City of Richmond

Report to Committee

To:	Planning Committee	**Date:**	March 17, 2015
From:	Wayne Craig Director of Development	**File:**	RZ 13-644767
Re:	**Application by Matthew Cheng Architect Inc. for Rezoning at 7751 Heather Street from Single Detached (RS1/F) to High Density Townhouses (RTH2)**

Sheet Title
SITE PLAN

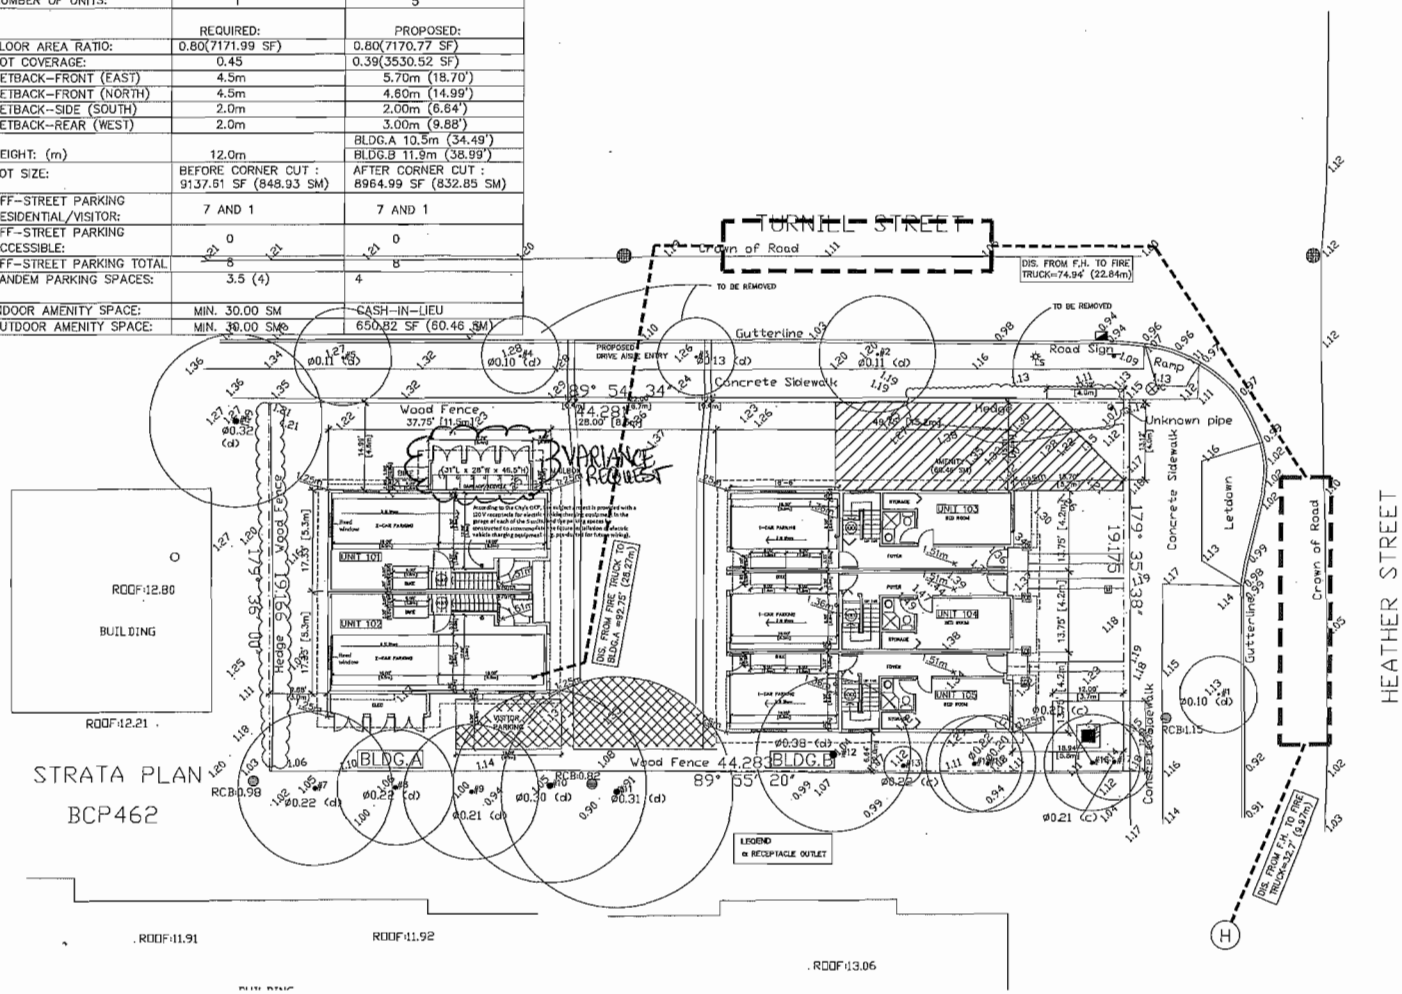
- Providing more defined private open space for individual units in the west building.
- Relocating visitor bicycle parking closer to the site entry.
- Examining opportunities to locate unit entries for the west building towards Turnill Street to provide a more pedestrian-oriented streetscape on both frontages.

- Modification to the garbage and recycling enclosure to further incorporate it into the west building and relocate the entry door to face the drive-aisle so as to provide an improved streetscape elevation along Turnill Street.

TREE MANAGEMENT DRAWING

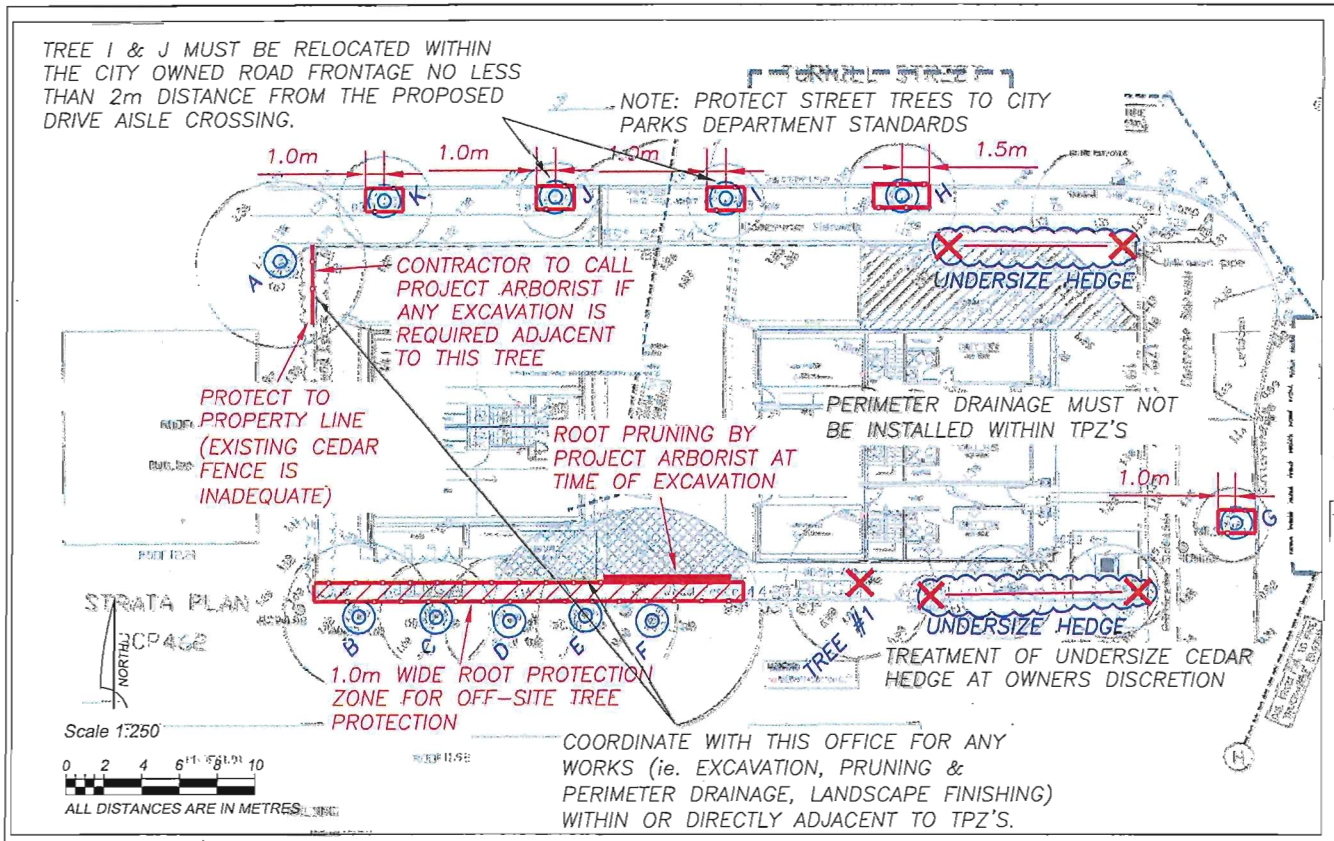
- Tree # 1 on the subject site (Laurel) should be removed, as it is in very poor condition with visible cavities at historical pruning cuts.
- The six (6) trees at 7833 Heather Street are to be protected in accordance with the Arborist's recommendations.

- Trees G, H, and K located in the boulevard on City-owned property are to be protected in accordance with the Arborist's recommendations, and Trees I and J are to be relocated within the boulevard on Turnill Street no closer than 2 m to the proposed driveway crossing to the subject site.

To ensure protection of off-site trees and trees to be relocated (i.e., at 7833 Heather Street, and on city-owned property), the applicant must submit the following items prior to rezoning approval:

- A contract with a Certified Arborist for supervision of all works proposed in close proximity to tree protection zones. The contract must include: the scope of work to be done, any protection measures required to ensure tree protection (e.g. root pruning during excavation and installation), as well as a provision for the Arborist to submit a post-construction impact assessment report to the City for review.
- A contract with a qualified tree relocation company.
- A survival security in the amount of $6,500 for Trees G, H, I, J, K on City-owned property [three (3) to be retained; two (2) to be relocated].

Tree protection fencing must be installed to City standard around all off-site trees to be protected, in accordance with the City's Tree Protection Information Bulletin TREE-03. Tree protection fencing must be installed prior to demolition of the existing dwelling and must remain in place until construction and landscaping is completed.
